MINUTES OF PREBID MEETING

Bid Identification No.:	AEGCL/MD/Tech-1142/TSAT/245kV GIS Extn./BID
NIT No.:	AEGCL/MD/Tech-1142/TSAT/245kV GIS Extn./NIT Dated 18.08.2026
Name of the Work	Turnkey Extension of Existing 245 kV GIS by Addition of 2 (Two) Nos. of 245 kV GIS Feeder Bays along with Associated Services at 400 kV Sonapur GIS Substation of AEGCL
Date of Pre-Bid Meeting	27/08/2026
Venue of Pre-Bid Meeting	Conference Room O/o the MD, AEGCL, 1st Floor, Bijulee Bhawan, Paltan Bazar, Guwahati-01

QUERIES ON BID DOCUMENT

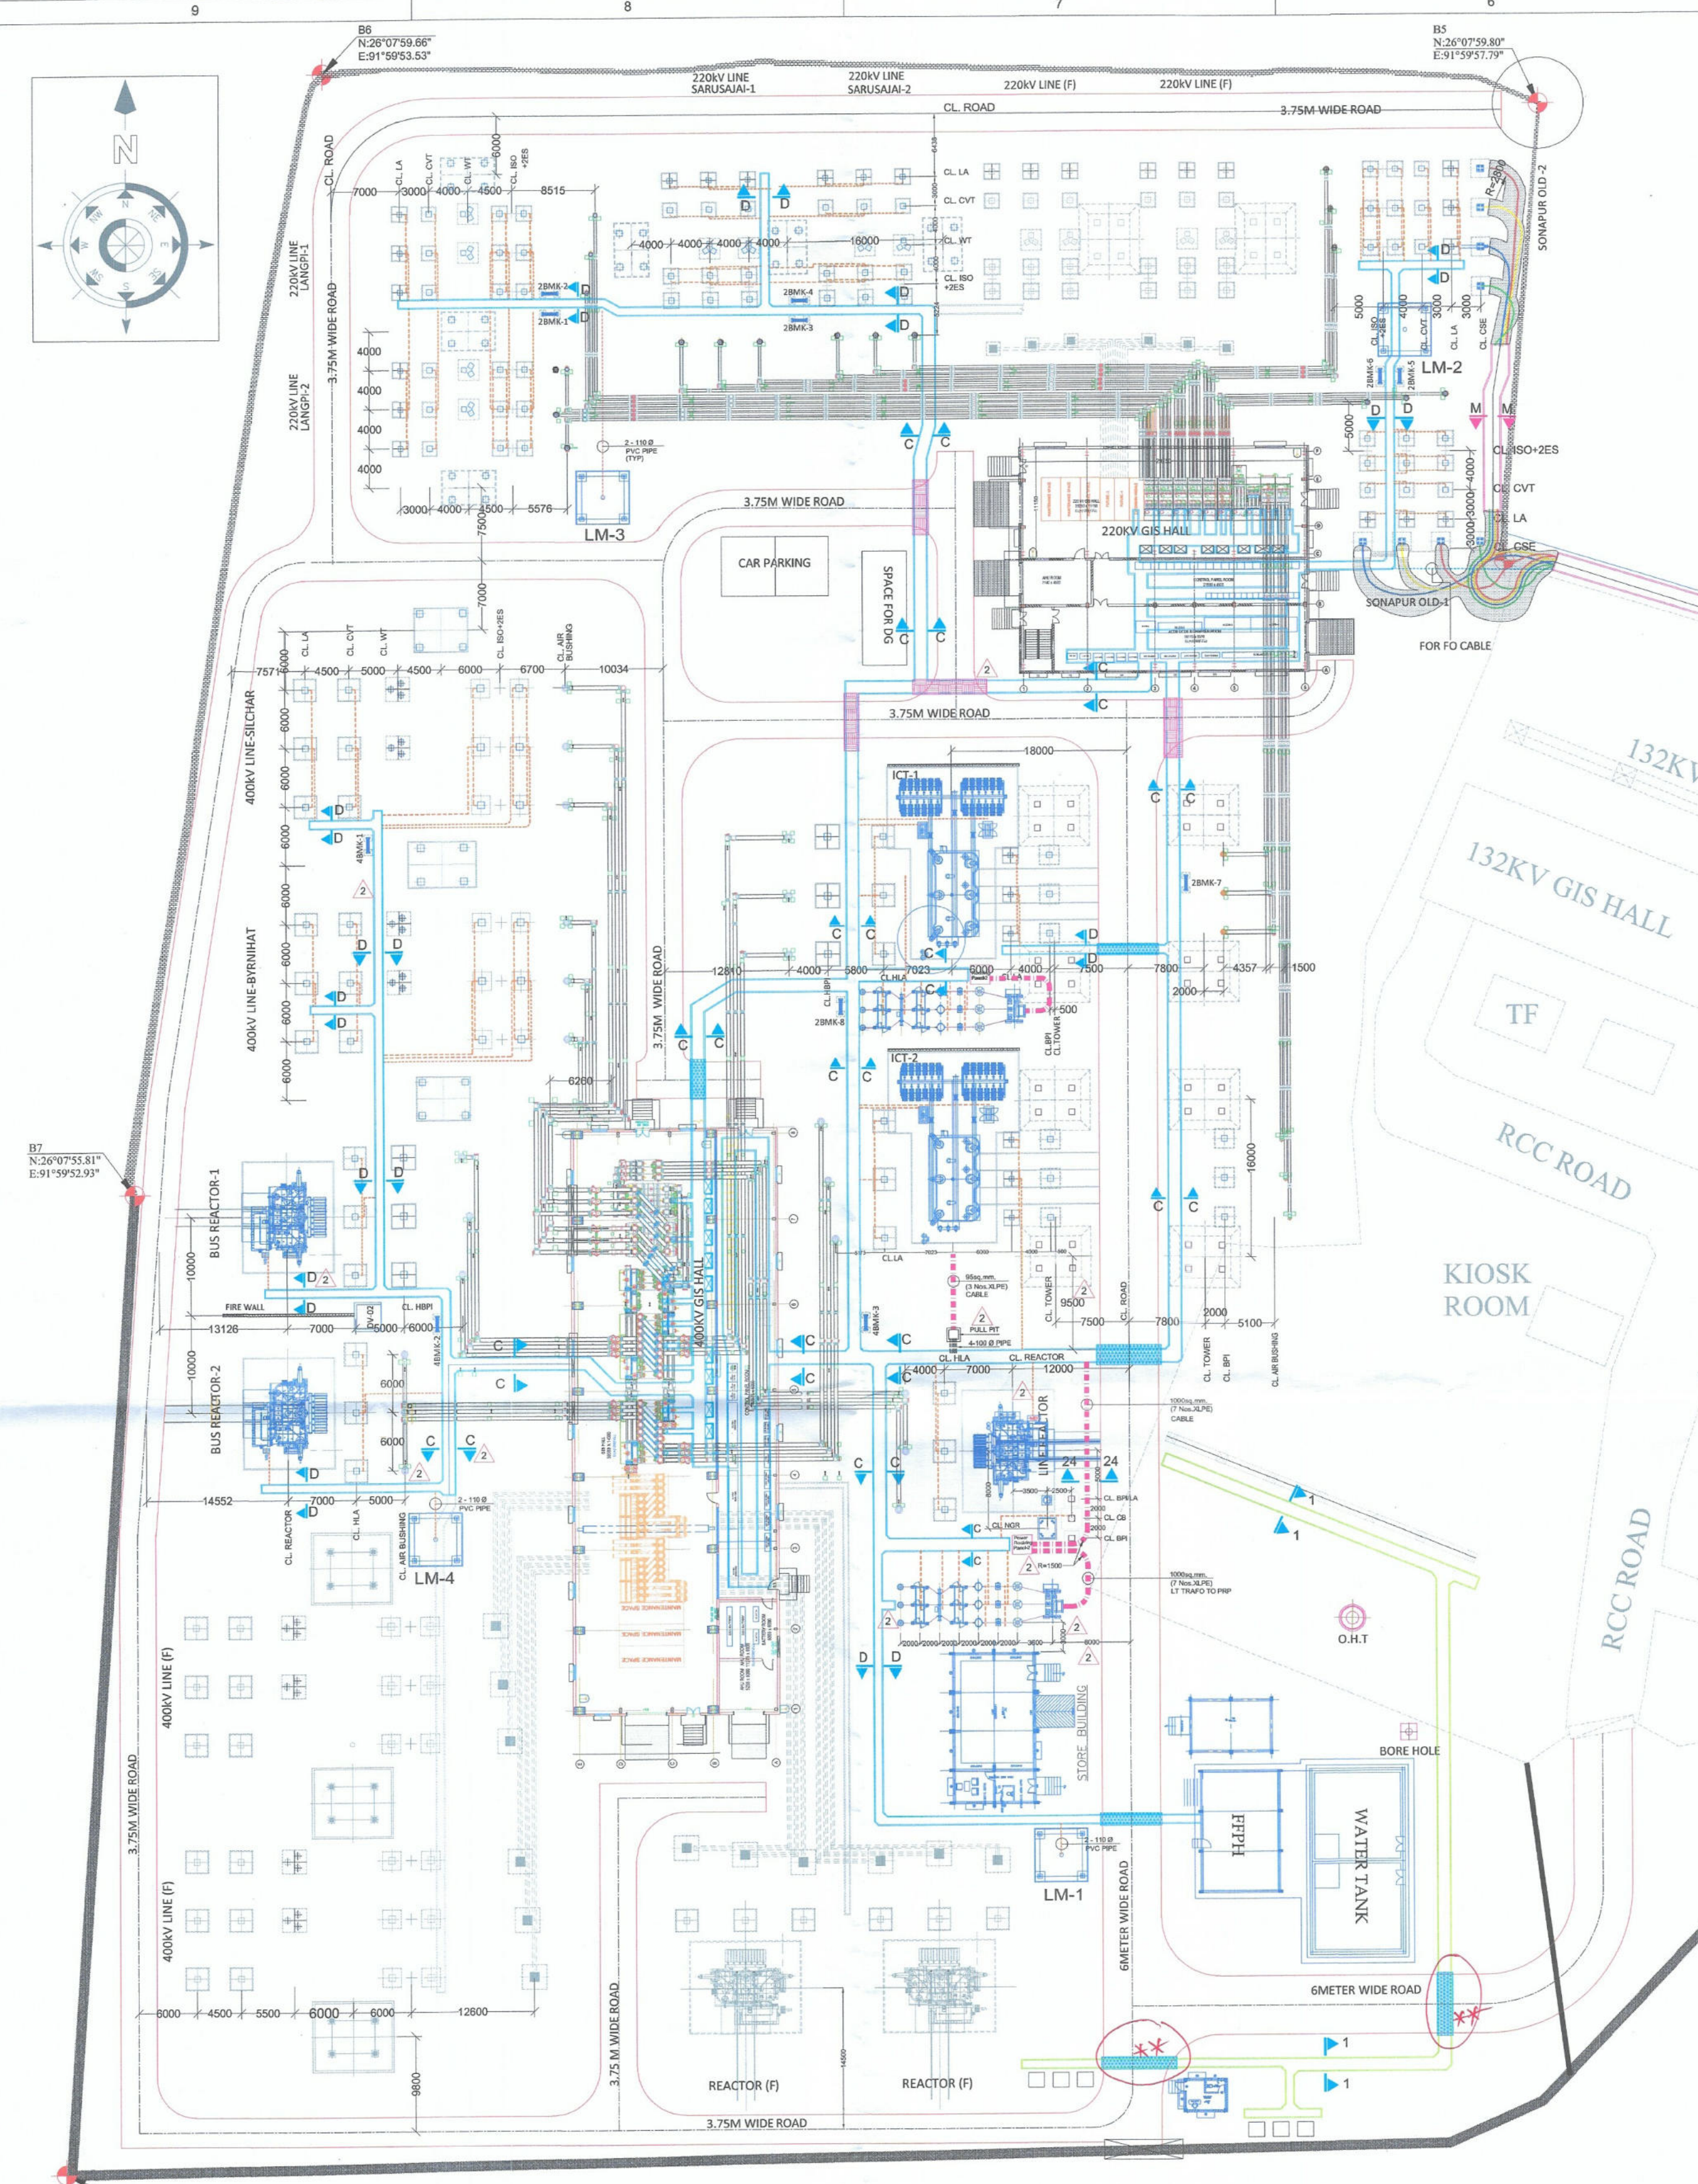
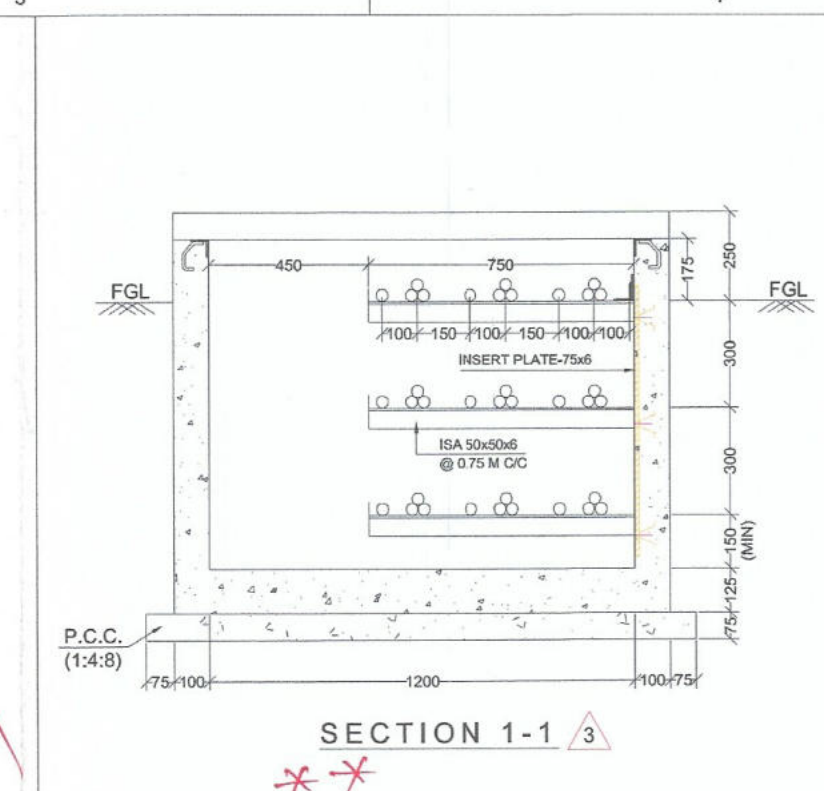
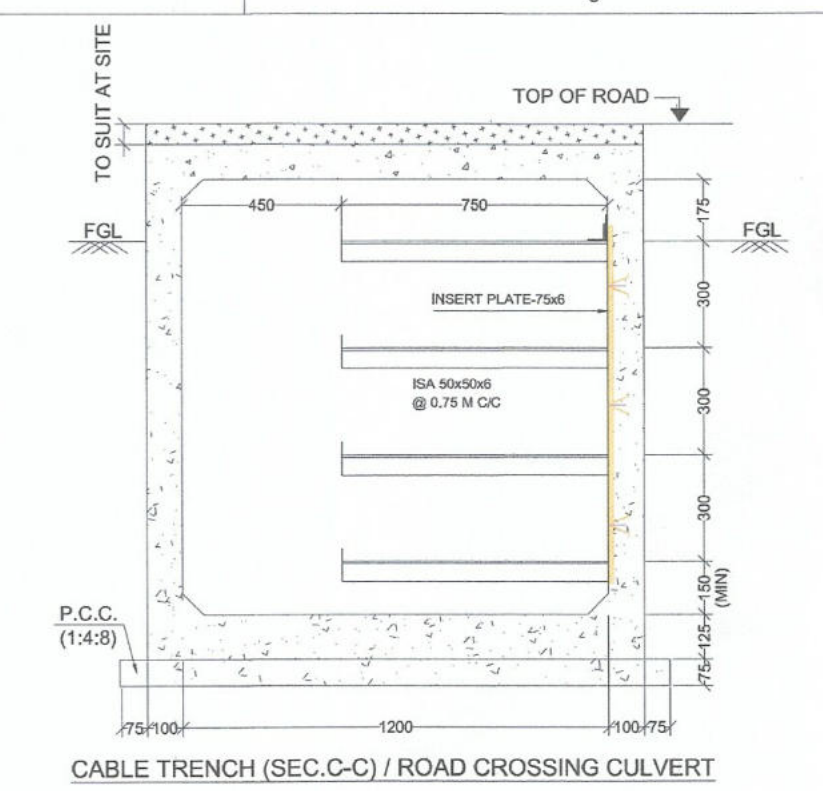
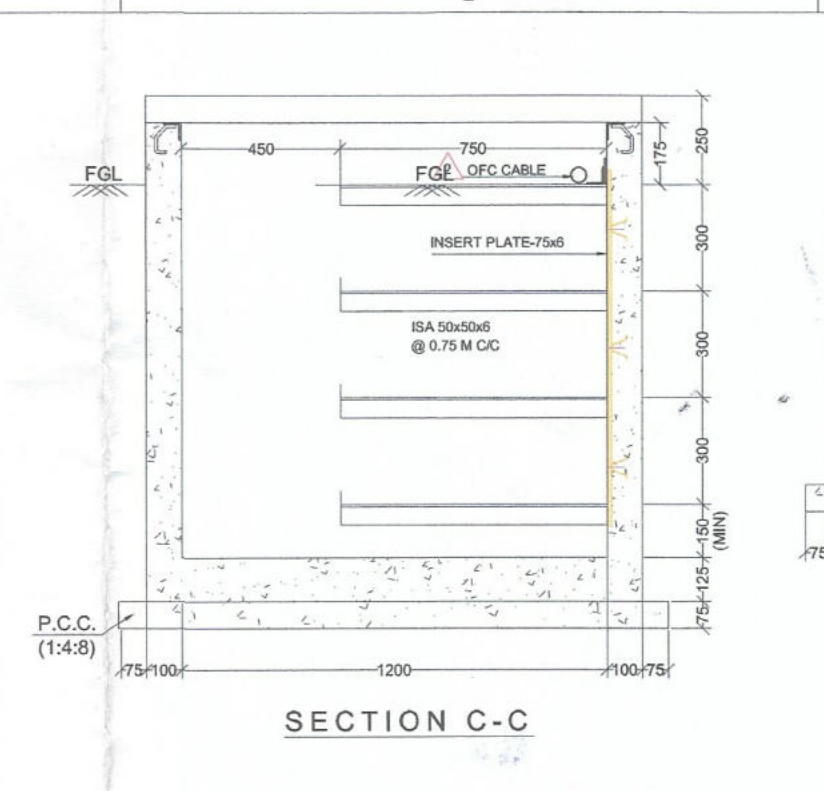
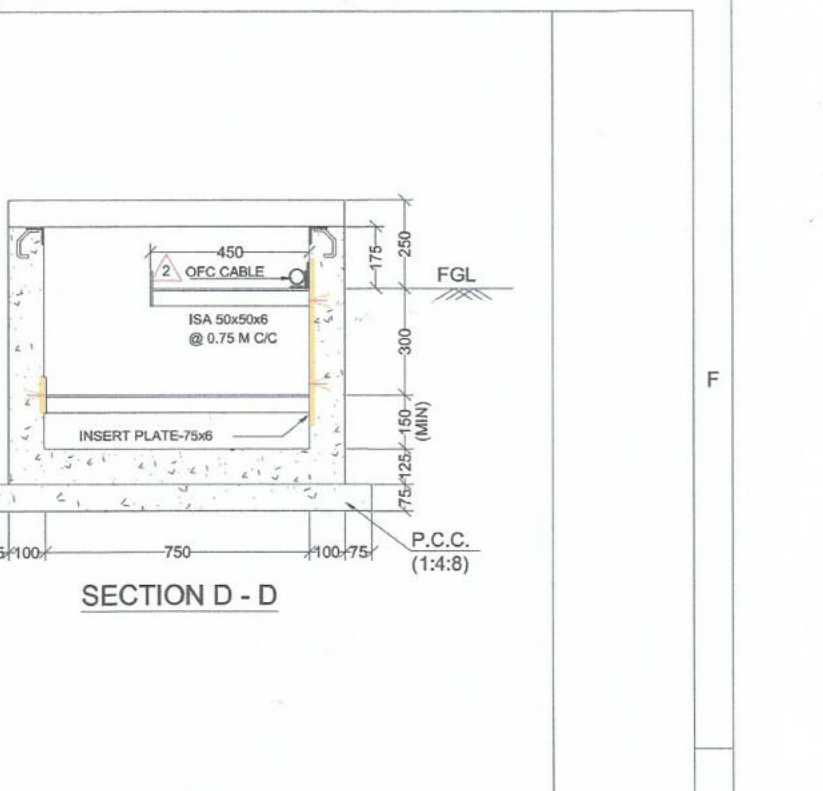
Top Cover Slab to be suitably Reinforced for the portion marked above

For FO Cable to be marked

** For Road Crossing portion as marked, Typical Section similar to Section C-C with dimensions pertaining to Section 1-1 shall be used.

** This typical sectional layout for road crossing to be submitted

** For This Section marked, The Cover Slab shall be suitably Reinforced for movement of Hydran for maintenance works.

For transition layer from Buried Trench to Cable Trench, suitable Sealing arrangement shall be made.

* Sectional drawing of the transition layer to be submitted.
